Fiat Scudo - Poor air conditioning system performance | HELLA

Scudo 1.6D Multijet 90

Year of manufacture: from 2007 until VIN 84160387

Poor air conditioning system performance

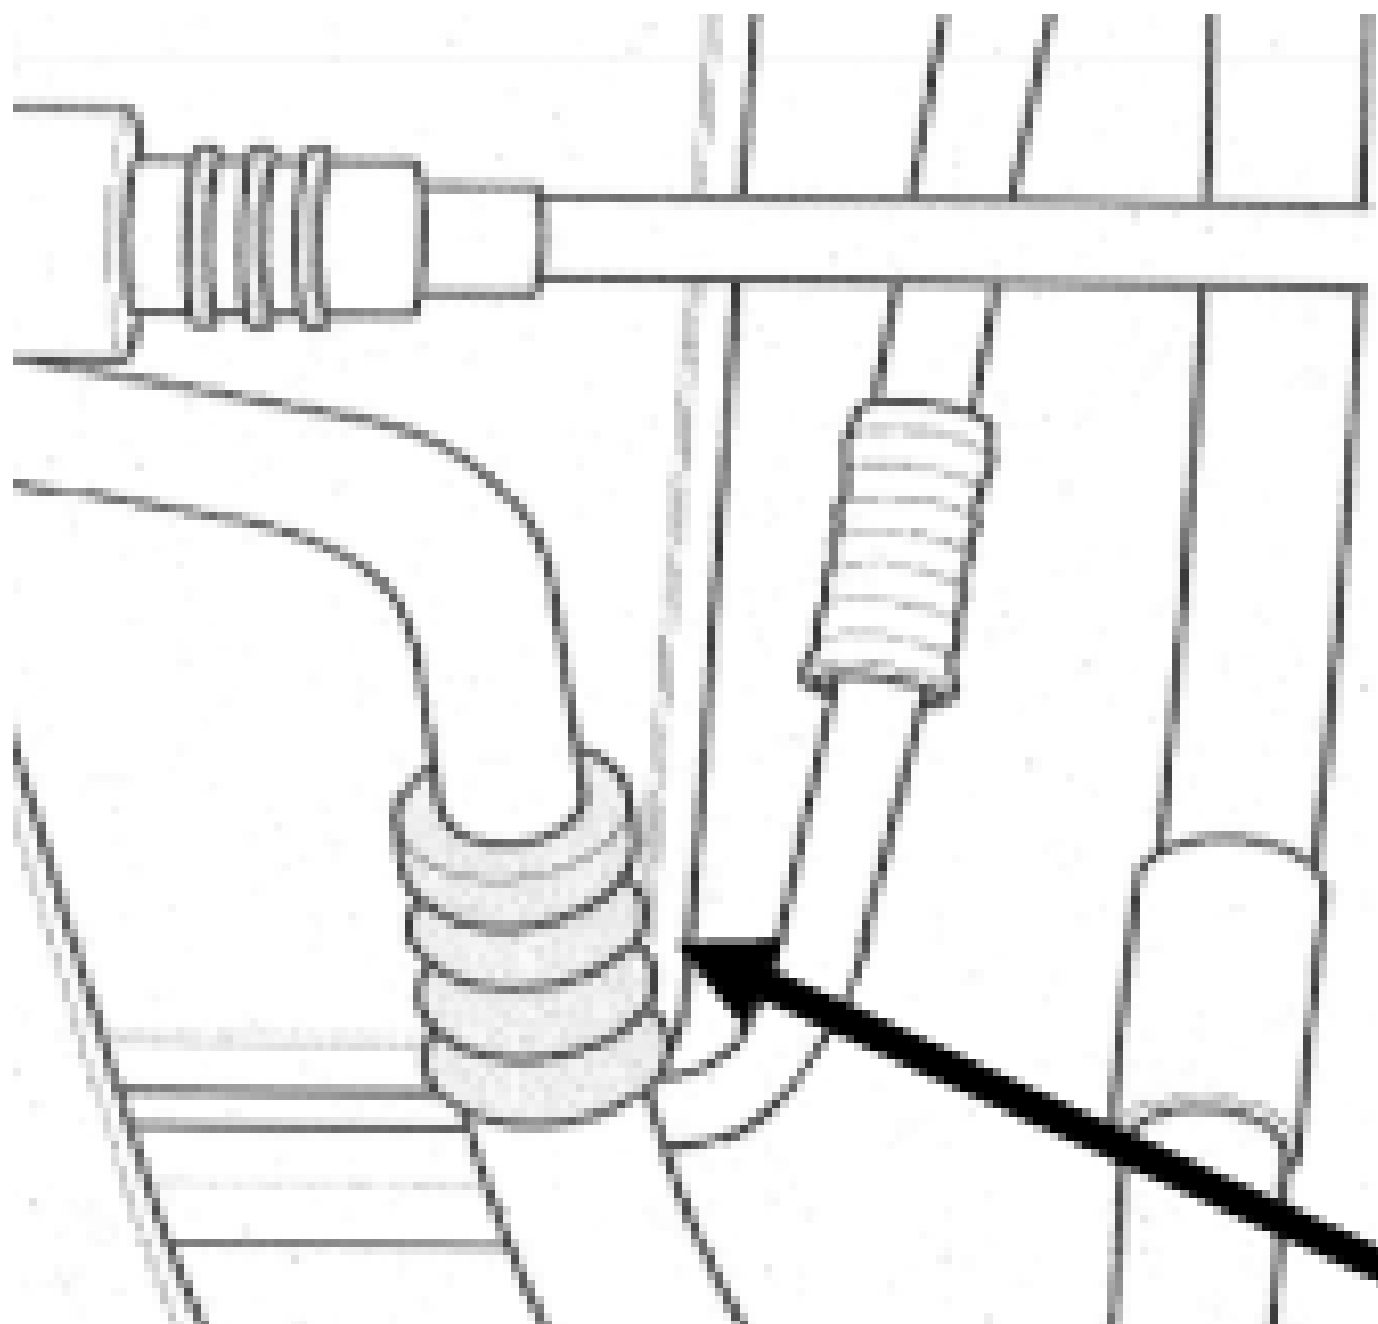
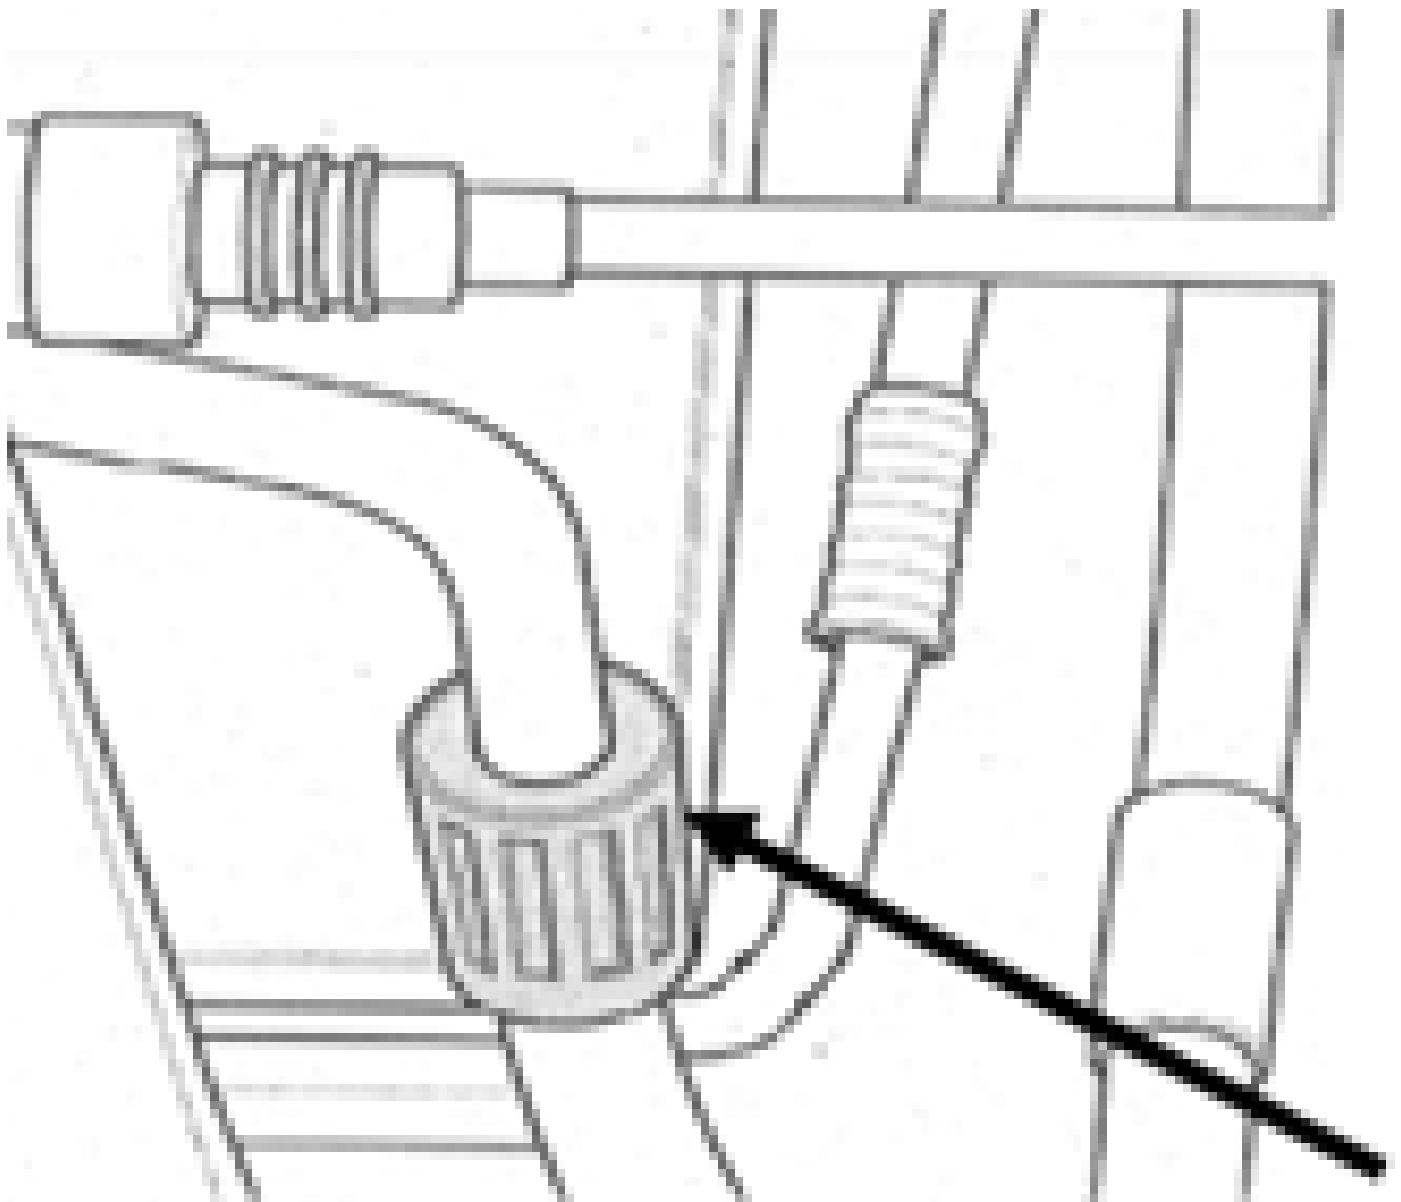
If the vehicles mentioned above experience poor air conditioning performance or a loss of coolant, the possibility of a coolant leakage between the condenser and compressor must be considered.

Check the coolant line for the correct model type and replace if necessary. (see figures)

- Old model types -

This is the modified model type from the vehicle manufacturer: [Spare parts]

- 1 unit: Coolant line: (Spare parts): 140142280

- 2 units: O-ring: (Spare parts): 9645950980
